RE: Arborist Report for Metric Architecture - For property located at 1805 Larch St., Vancouver, BC

Key Policy: Moderate Income Rental Housing Pilot Program (MIRHPP)

REZONING ENQUIRY SUBMISSION:
1805 LARCH STREET @ WEST 2ND AVENUE

FLOOR PLAN
LEVEL P2

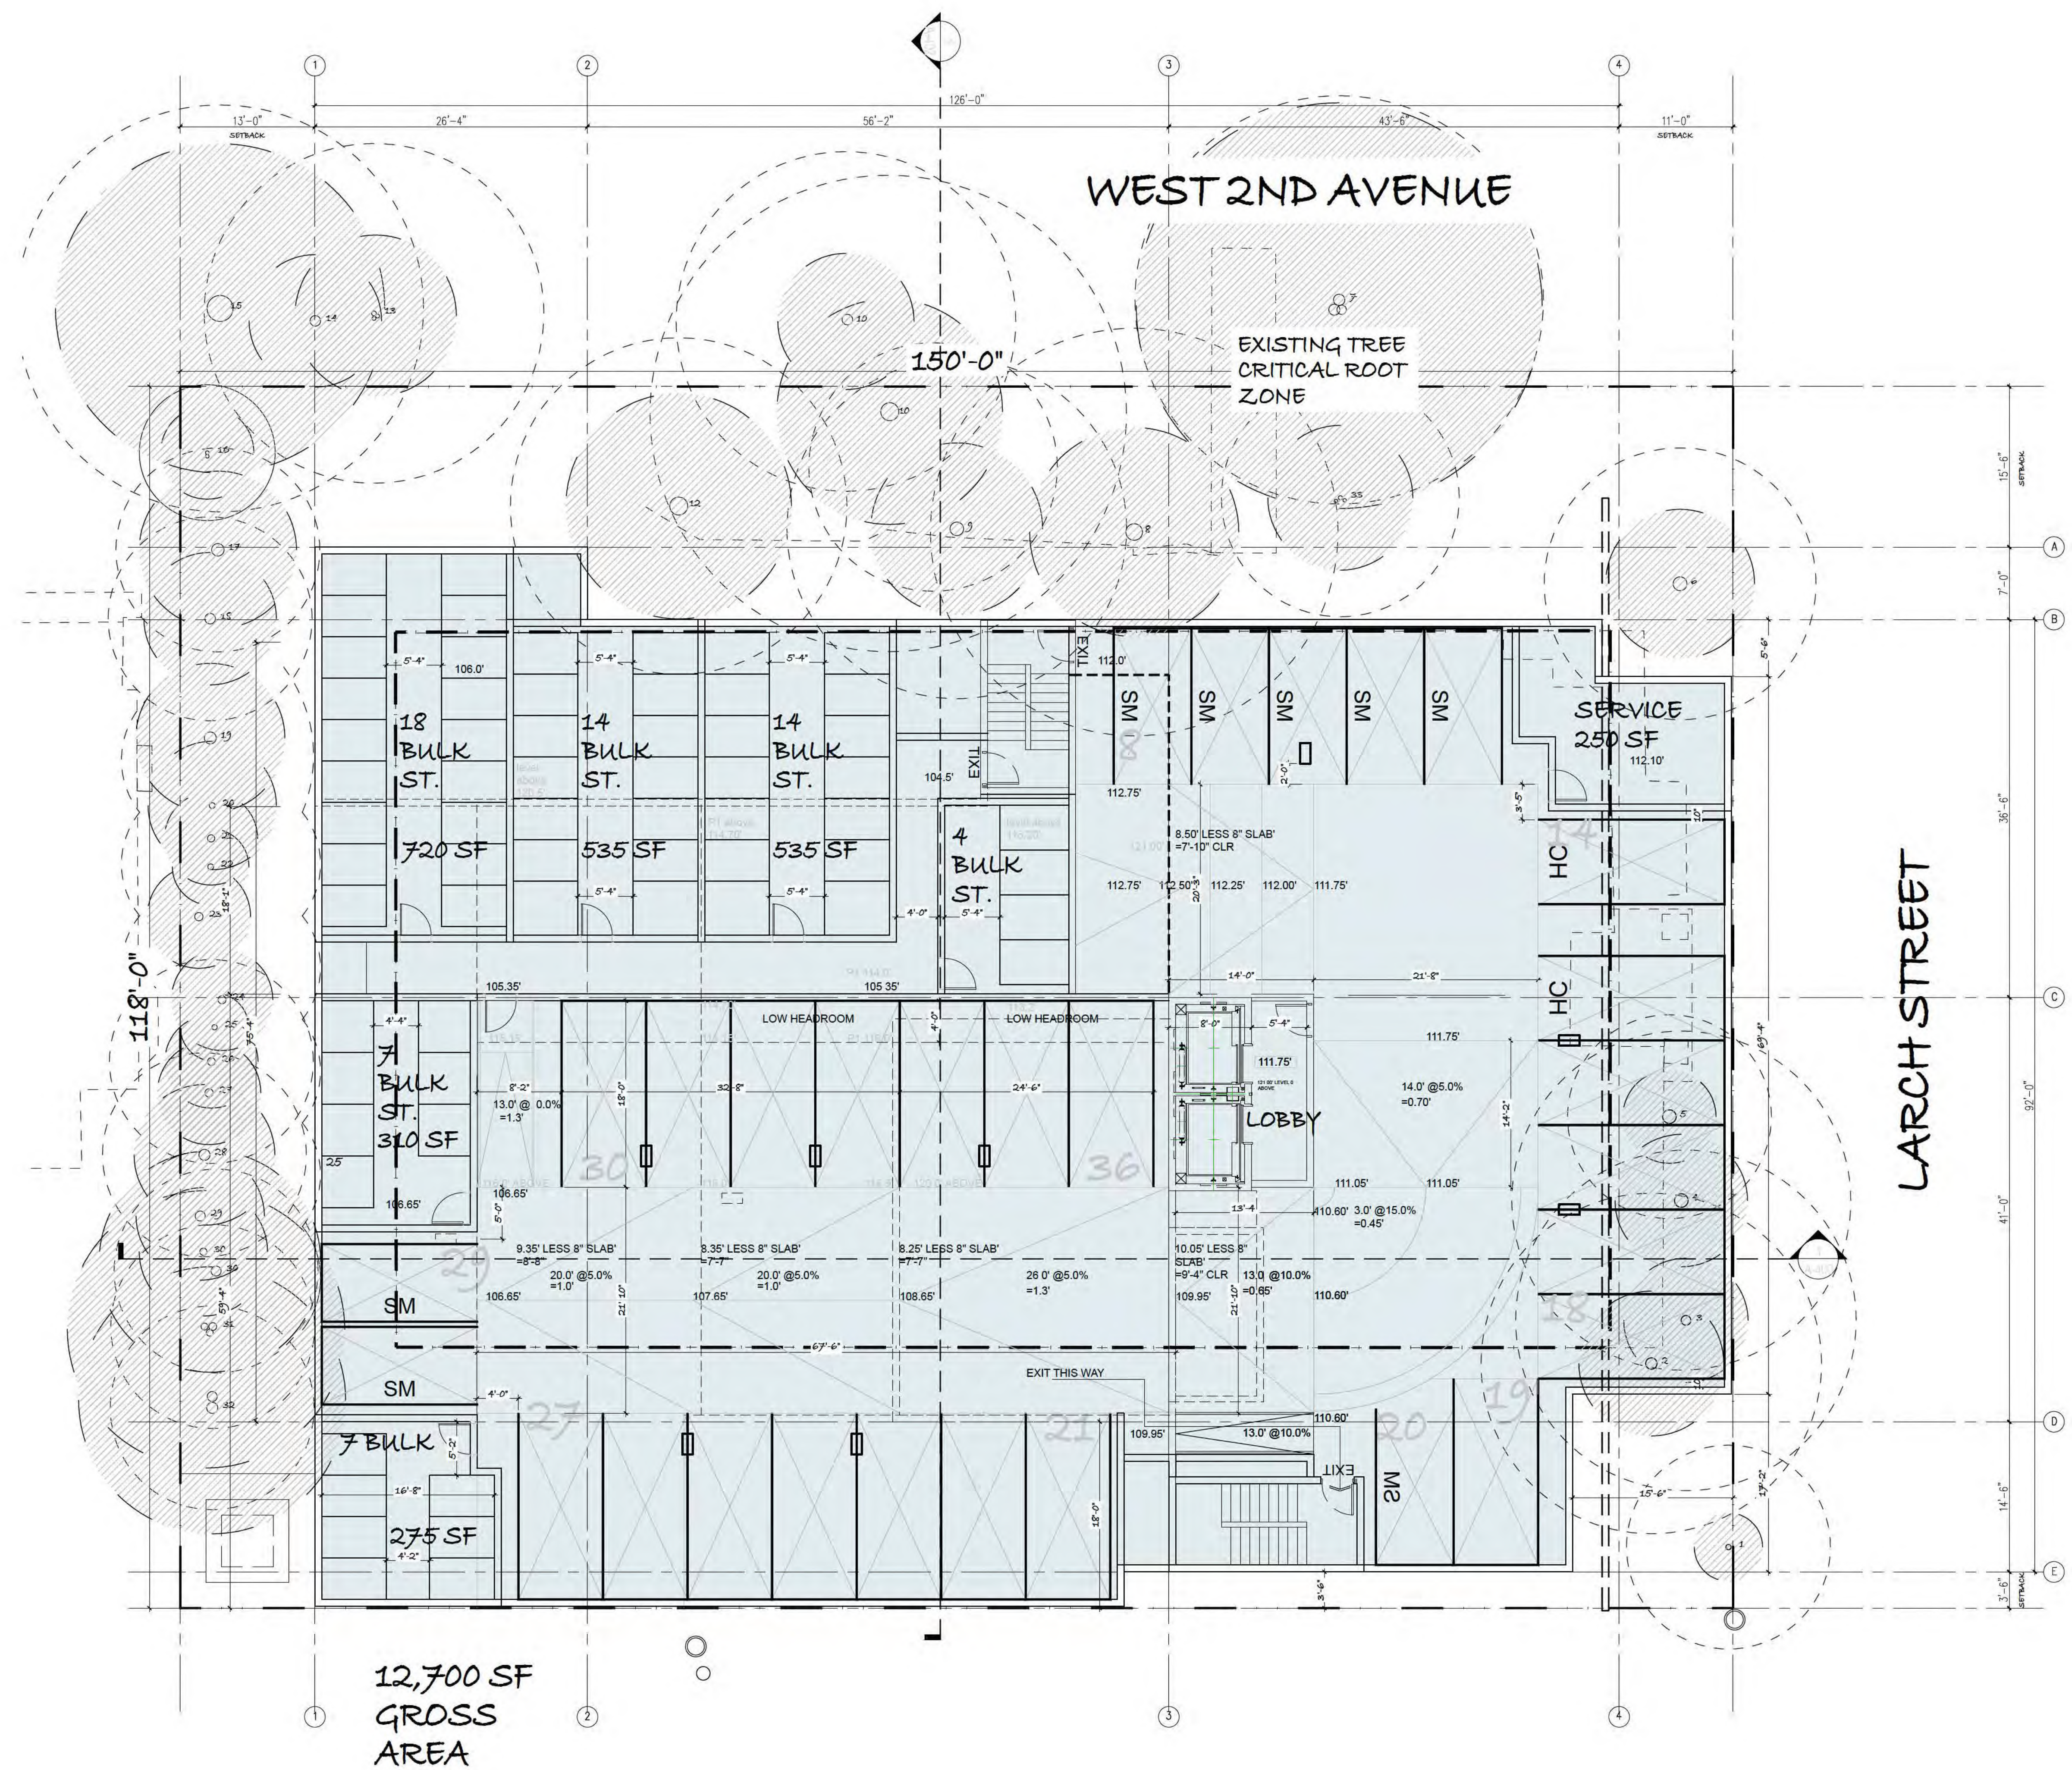
- Provide adequate natural light for all dwelling units by providing windows for bedrooms along the west elevation and providing a north/south section through 1B for units on Parking Level 1
